Title: Sletten-Courthouse Renovation Judge's Recommendations

A&E Design Arch Bulletin

Courthouse Renovation-Judge's Itemized Requests

sheet LEVEL 1 MEZZANINE DEMOLITION PLAN
project YELLOWSTONE COUNTY COURTHOUSE
owner YELLOWSTONE COUNTY

16 LEVEL 1 MEZZANINE DEMO
3/16" = 1'-0"

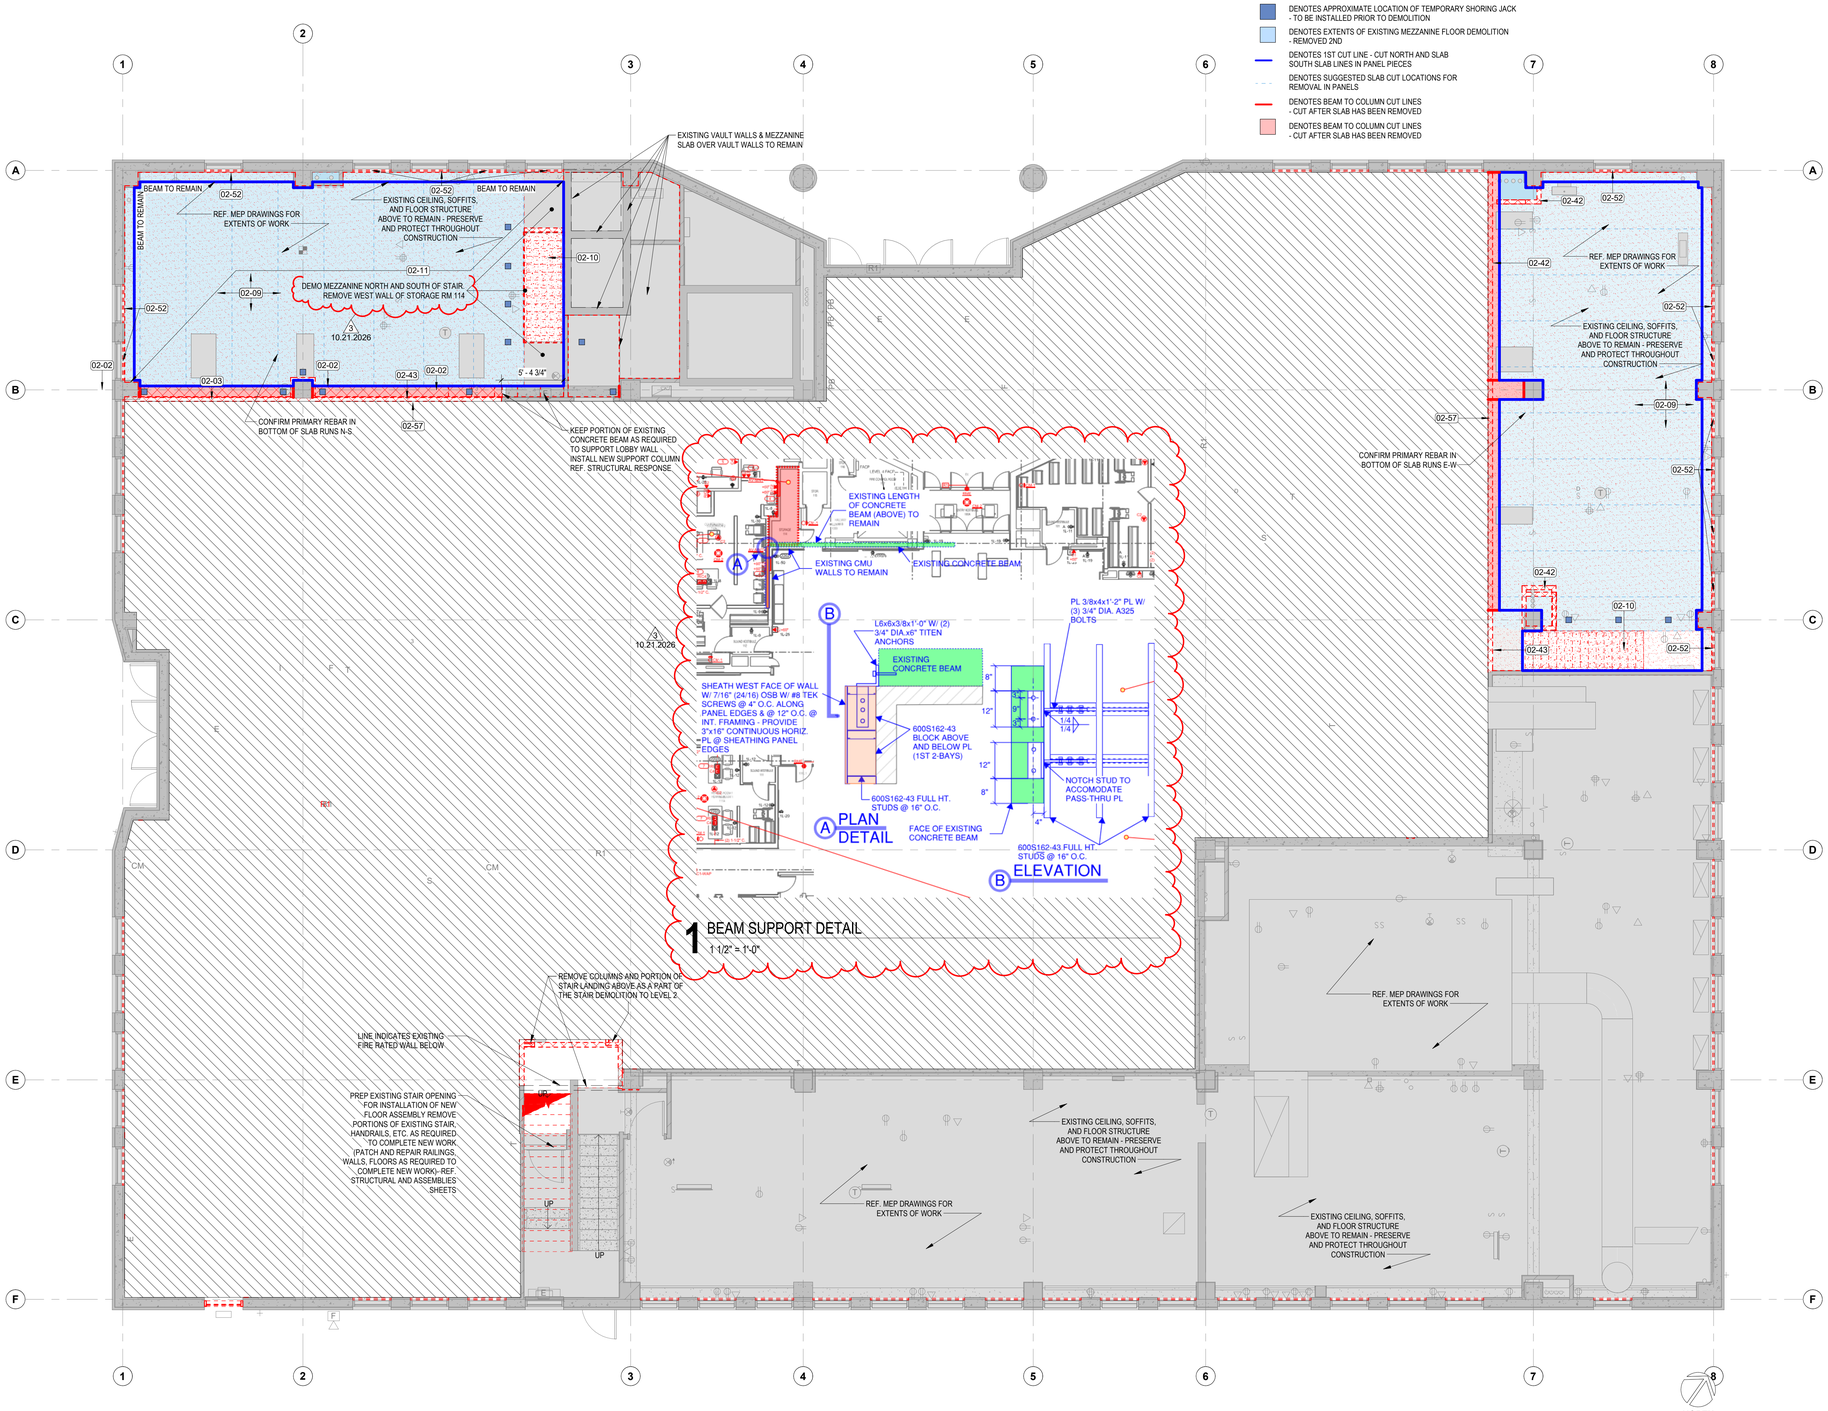
Krivonen, please review the feasibility of removing the mezzanine above the closet in NW courtroom.

- Demolish the walls enclosing Storage 114 and the mezzanine above, and use this area for the jury box.
- Provide power and data at the podiums.

02-57	DEMOLISH MEZZANINE LOW WALL AND WOOD PANELING CLOSING OFF INTERSTATIAL SPACE OF ADJACENT ROOM.

17 ENLARGED PLAN - 101A COURTROOM 1
1/4" = 1'-0"

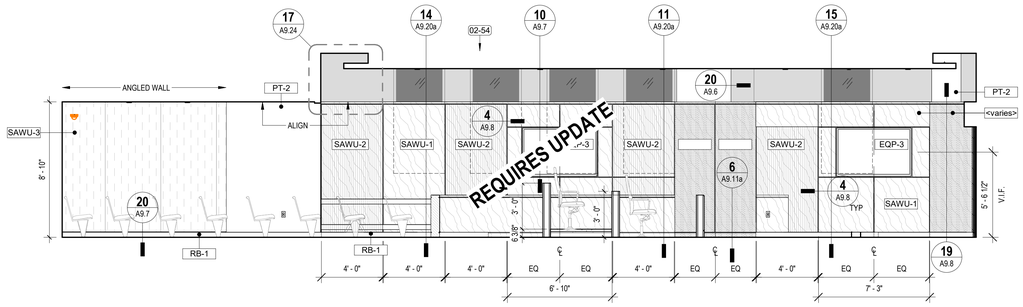
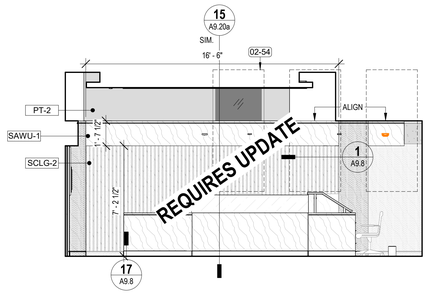
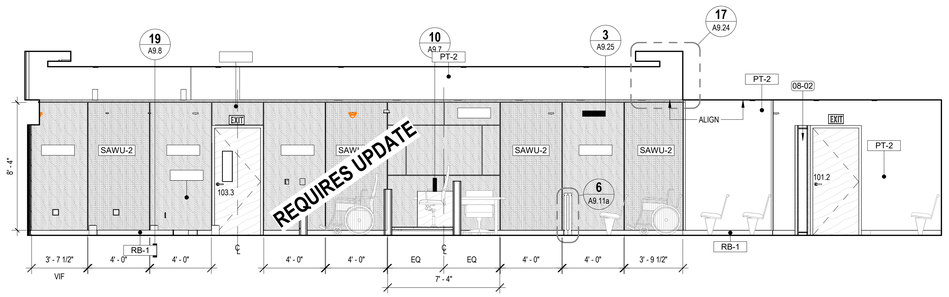
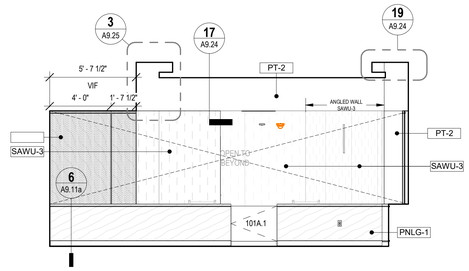
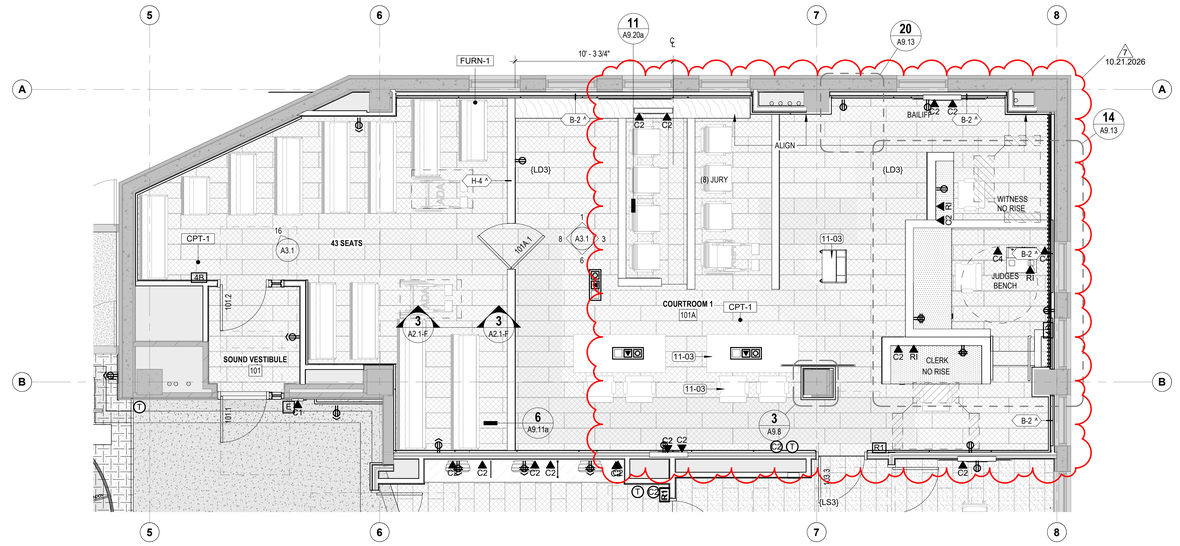
Courtroom 101A

- Modify the ceiling design per the attached markup.
- Move the witness stand as far north as possible to provide more space at the judge's desk.
- Provide power and data at the podiums.
- Provide a destratification fan. This room may regularly accommodate 30–40 people.
